الموضوع: لعملية إنشاء نفق سيارات (دير الأنبا مقار) عند الكم (213+965) أسفل مسارالقطار الكهربائي السريع (العين السخنة- العلمين).

تنفيذ / شركة الغرابلي للأعمال الهندسية المتكاملة ش.م.م

SUBMISSION OF SHOP DRAWING
SAINT MACARIUS MONASTERY TUNNEL

Shop Drawing

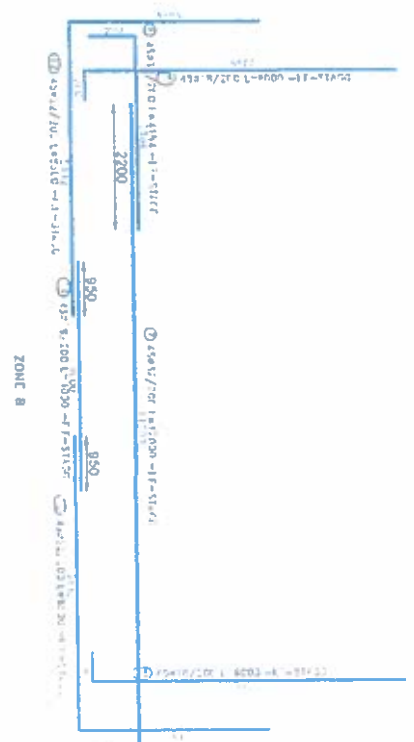
Refer to comments at sheet (1/10)
